1991 Corvette: Service Bulletin: Squeak and Rattle Diagnosis Guide

Subject: SQUEAK AND RATTLE DIAG. GUIDE DIAGNOSTIC AID/CORRECTION

Model and Year: 1991 CORVETTE

Bulletin Number: 91-264-10 - (03/25/1991)

FIGURE 1

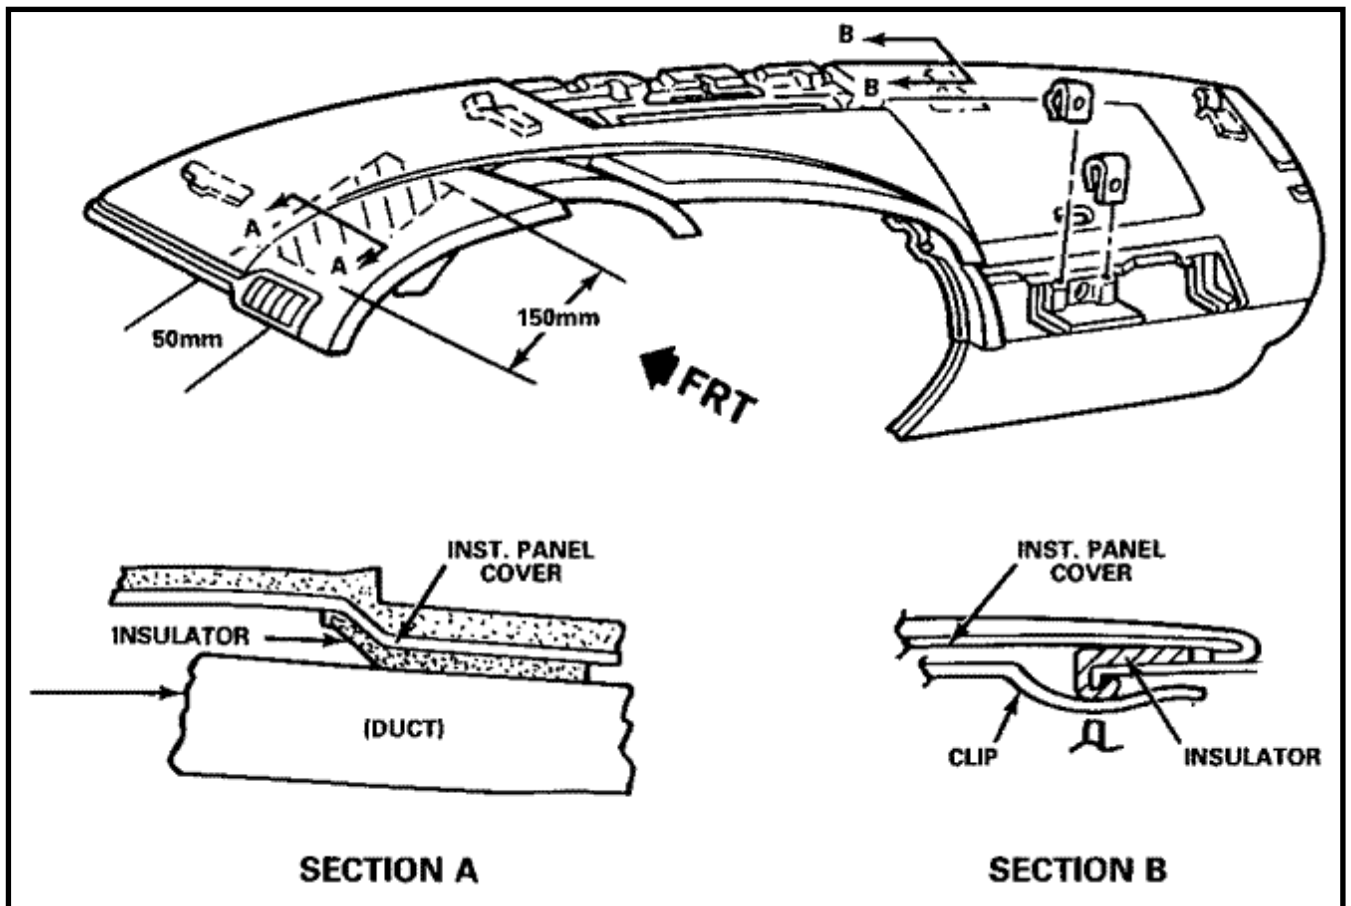
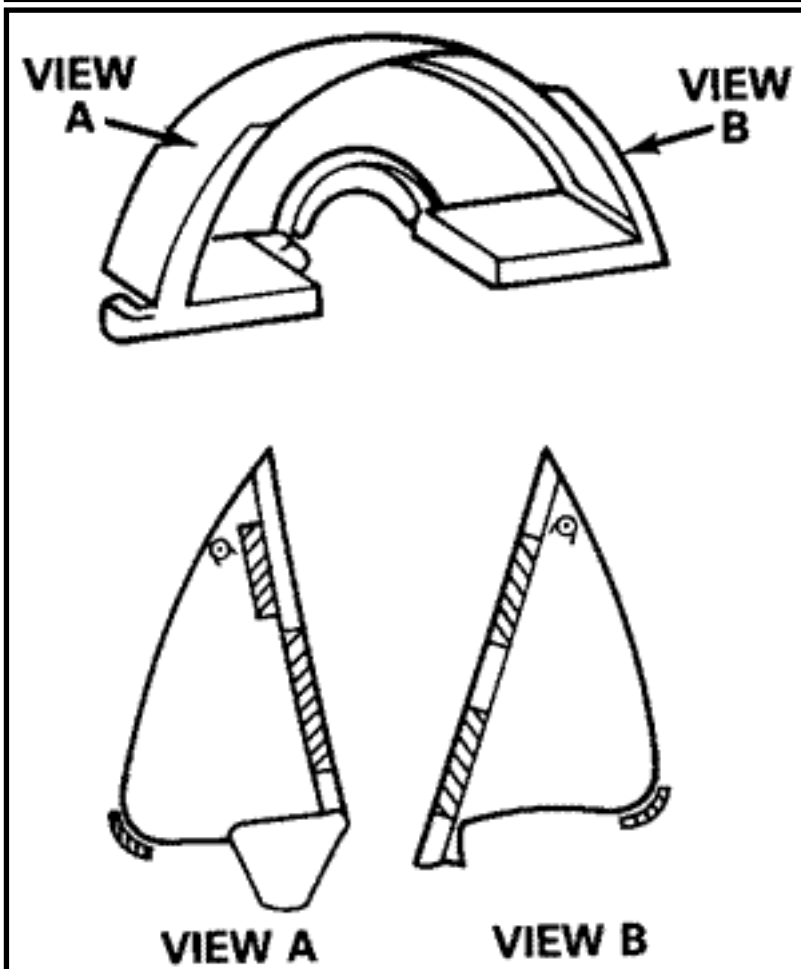
1. Rattle forward of gages cluster 1. Insulate area shown in Figure at A/C cross car duct. 1 and Figure 1, Section A (felt material).

2. Rattle at front edge of cover 2. Reposition existing, or near windshield. install felt insulators on metal opening at all retainers, (see Figure 1, Section B). - Left defogger outlet

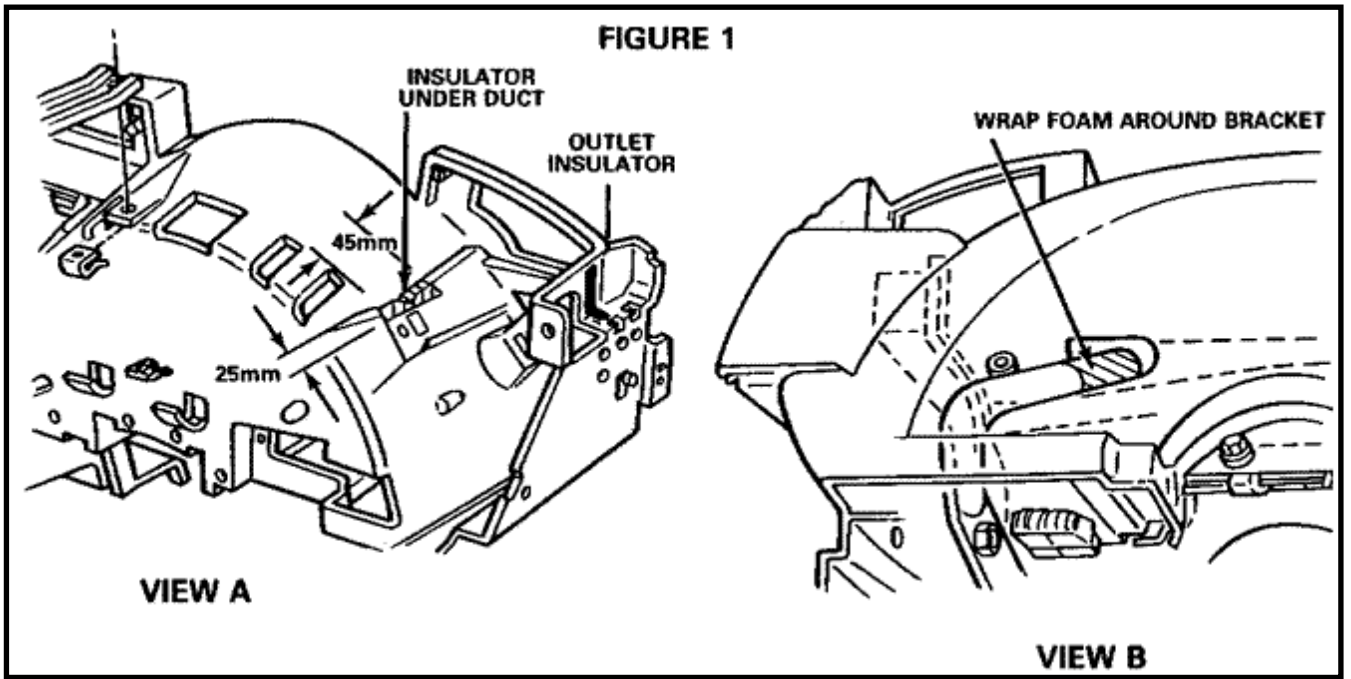
1. Buzzing against instrument 1. Apply felt insulator (1/2" X panel housing. 3"

as shown in Figure 2, view A). - A/C cross car duct

1. Rattle at top of instrument 1. Apply foam insulator (1/8") panel housing. to housing as shown in Figure 2, view A.

2. Rattle at left side SIR 2. Apply foam insulator (1/8") bracket. around bracket as shown in Figure 2 view B. - Instrumentation area

FIGURE 3

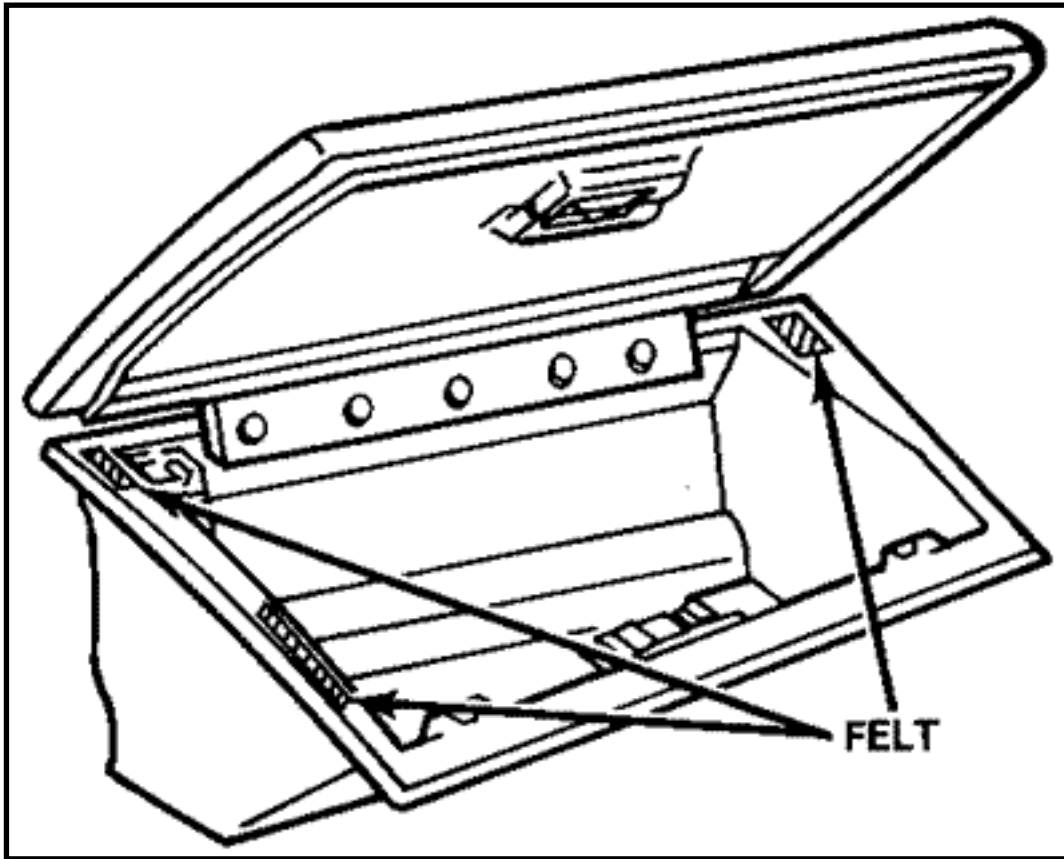
1. Squeak in instrument cluster 1. Apply felt insulators to bezel to cover. bezel edges and surfaces in locations as shown in Figure 3, views A and B.

FIGURE 5

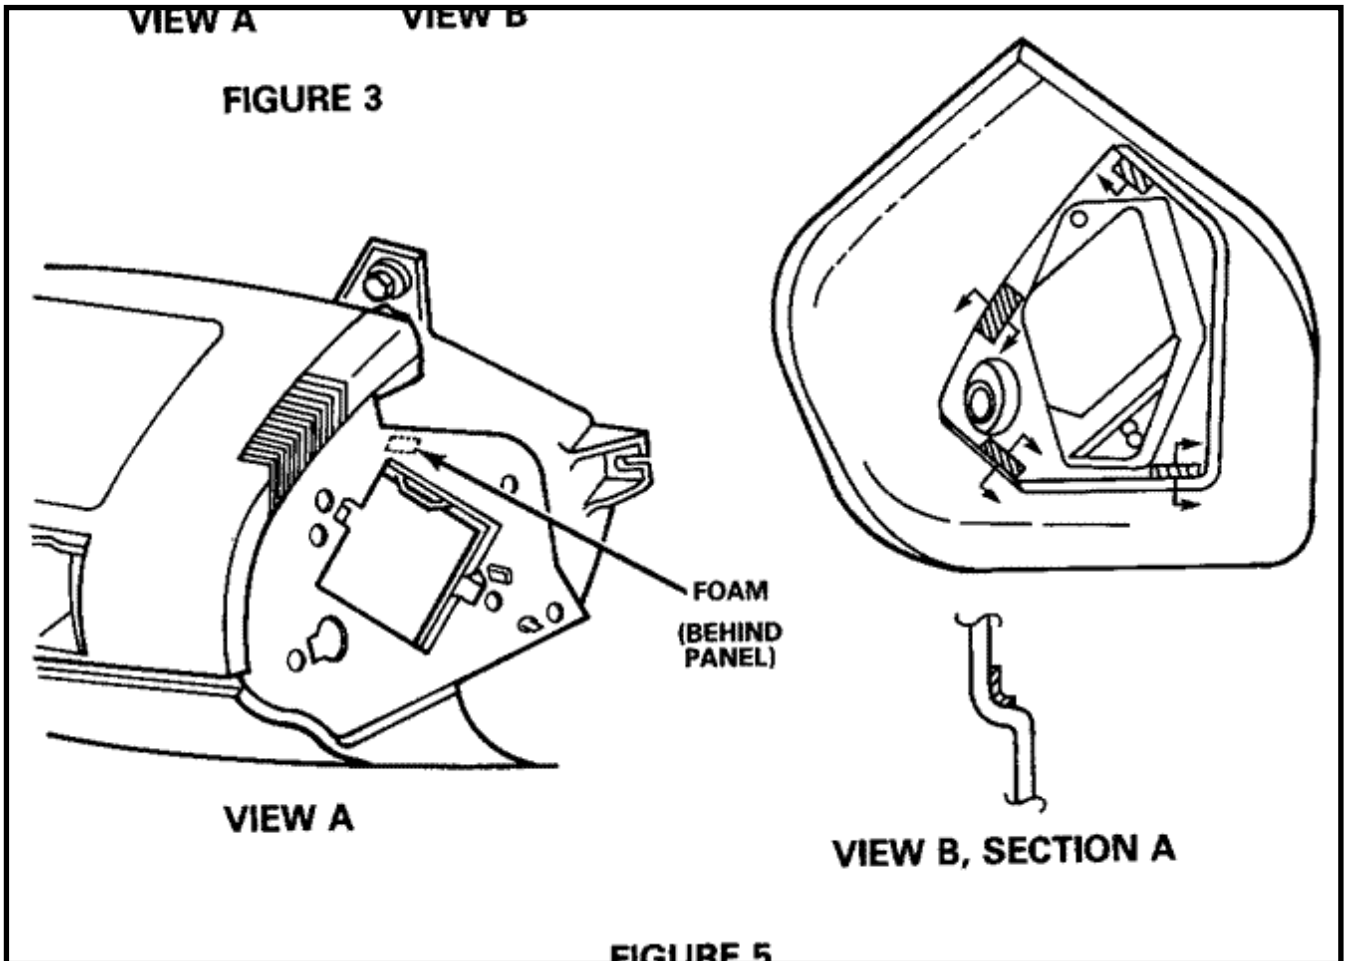
2. Buzzing of fuse box rivet 2. Apply small 1/4" foam heads to instrument panel insulator between rivet head cover. and cover as shown and cover as shown in Figure 5, view A.

3. Buzzing of fuse box door 3. Apply felt insulators (1/4" X in the opening. 1") as shown in Figure 5, view B. Position felt into the radius of the opening.

**REMOVABLE ROOF, FRONT
BOLT AND RETAINER**

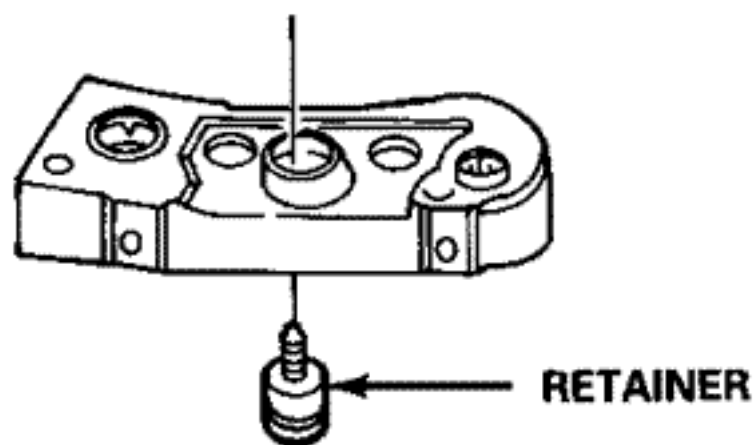
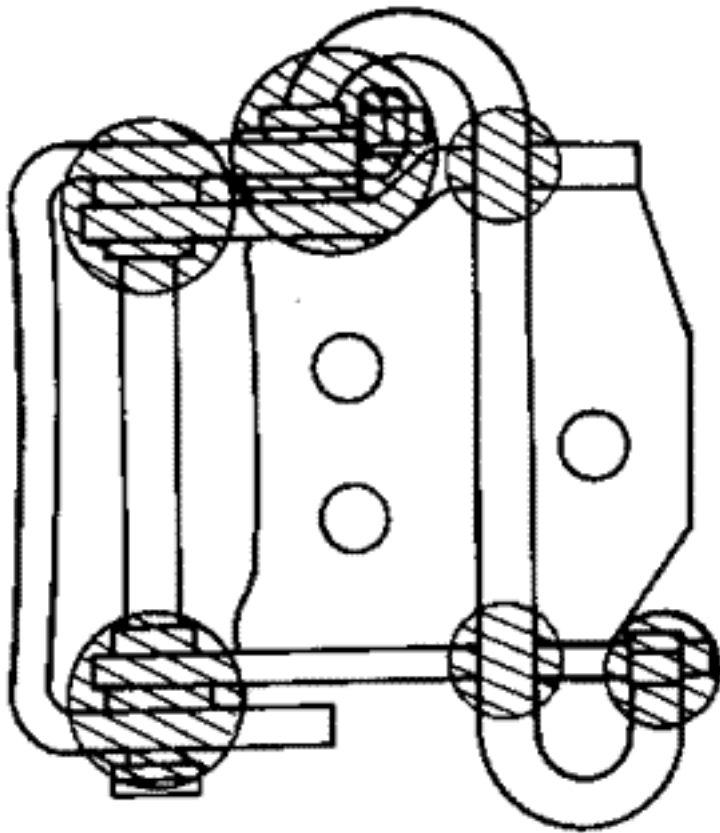
1. Rattle of front attaching bolts 1. Install new bolt retainers, when panel is stowed in rear. P/N 10 1 75804, see Figure 8.

1. Soak new retainers in warm water to aid in installation.
2. Remove roof panel and stow.
3. Remove upper trim covers at right and left latch areas.
4. Remove right and left sun visors, inside mirror and center garnish molding.
5. Carefully pry original retainer and bolt out of housing using a flat blade screwdriver or other suitable tool.
6. Install bolt in new retainer, align locating rib on retainer with notch in housing and press into place with a "C" clamp and socket.
7. Reinstall garnish molding, inside mirror, sun visors and upper trim covers.

- **PRY BOLT & RETAINER OUT
OF HOUSING WITH FLAT
BLADED SCREWDRIVER**
- **ALIGN LOCATING RIB WITH
NOTCH IN HOUSING**
- **PRESS INTO PLACE WITH
'C' CLAMP**

**LUBE AT SHADED AREAS
DOOR UPPER HINGE**

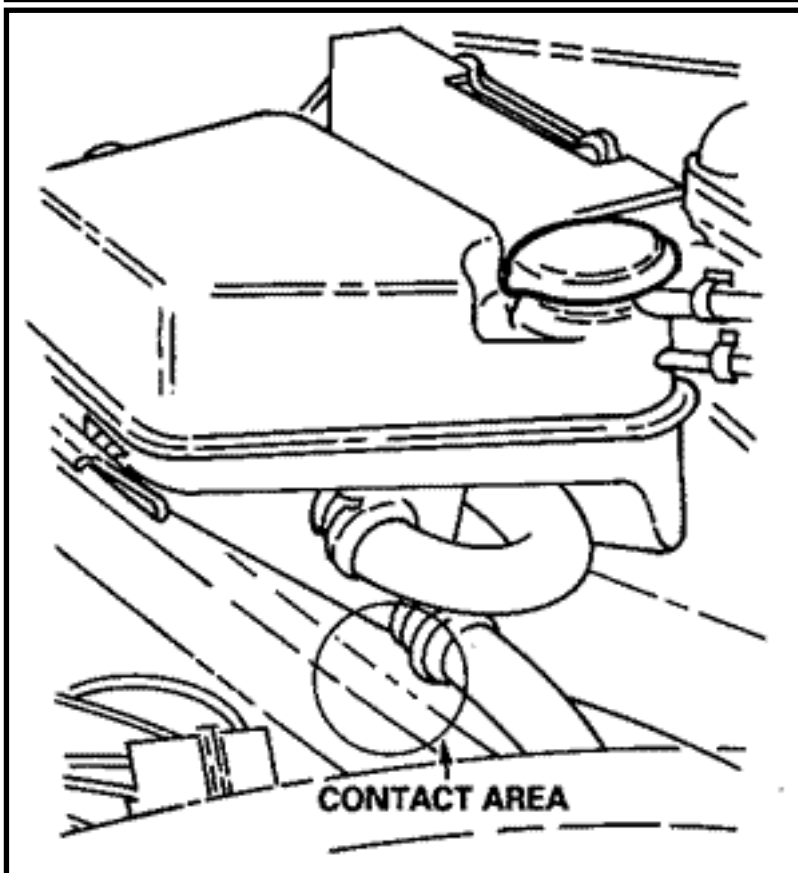
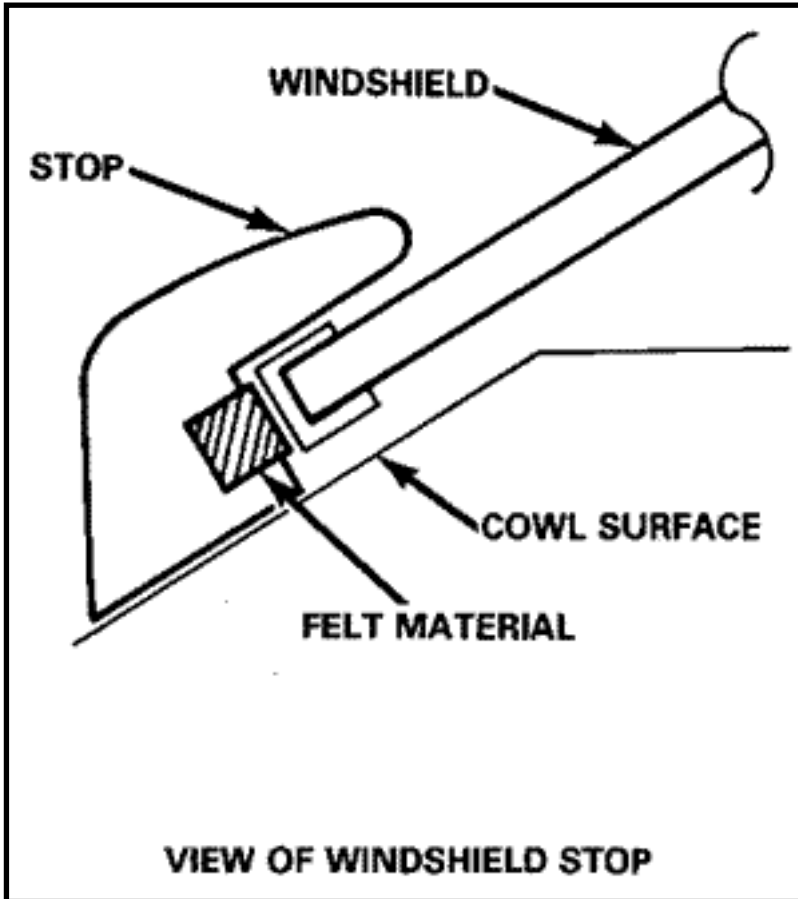
1. Squeaks when opening doors at 1. Lubricate ALL hinge torque hinge torque rod contact areas. rod contact areas with 30 wt. motor oil or grease, see Figure 9. UNDER THE HOOD ----- COMPONENT
